# California Drive *Intersection Improvement Project*

*Public Meeting #2*  
*May 24, 2016*

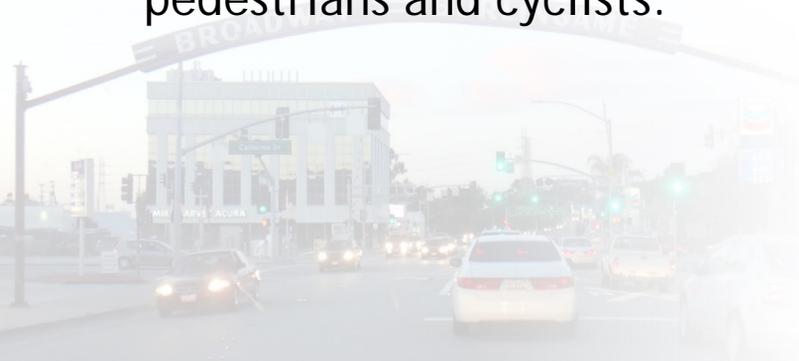
- Q: Will there be lighting in the pedestrian crosswalks as part of the project?
- A: Street lighting will be included in the project, and this will include lighting the pedestrian crossings with safety street lighting (overhead lights).
